Ridge to Reef Ecosystem Restoration in Solomon Islands (R2R-ERSI)

Review PIF and Make a recommendation

GEF ID
12289
Countries
Solomon Islands
Project Name
Ridge to Reef Ecosystem Restoration in Solomon Islands (R2R-ERSI)
Agencies
IUCN
Date received by PM
3/4/2026
Review completed by PM

GEF-8 PROJECT IDENTIFICATION FORM (PIF) REVIEW SHEET

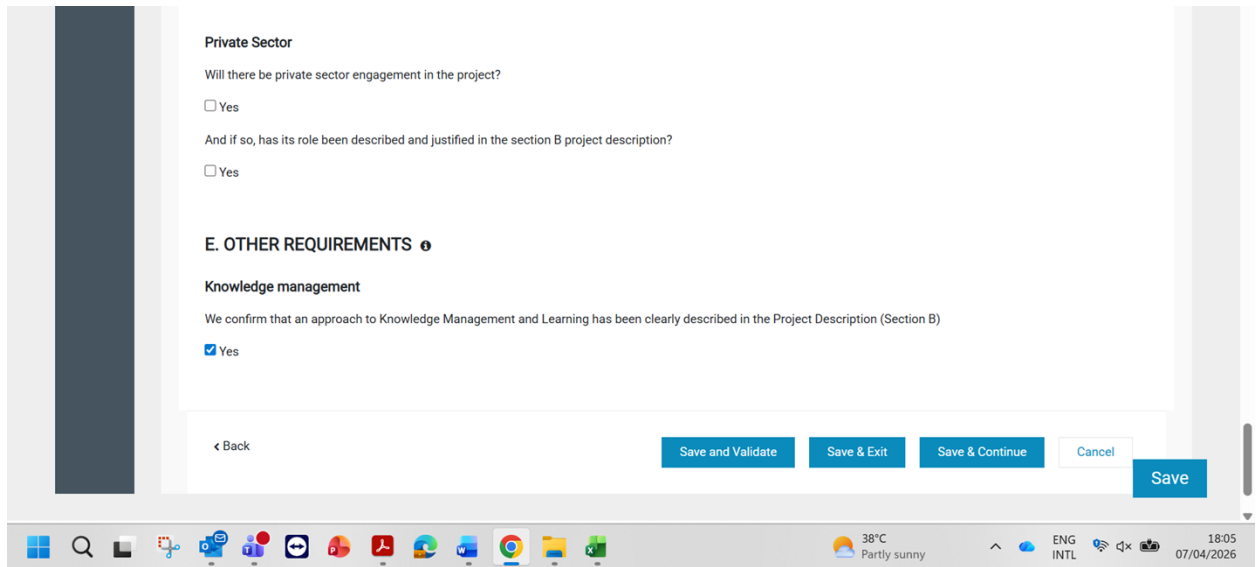
Will there be private sector engagement in the project?

And if so, has its role been described and justified in the section B project description?

Not cleared. Please precise for Private sector, engaged or not in the project.

Thank you very much for your comment. Kindly note that in the portal we have not answered as evident from the screenshot there is only an option to select Yes and there is no option to select otherwise. As of now there is no private sector engagement in the project.

Thank you very much for your comment. Kindly note that the private sector is not directly engaged in the project
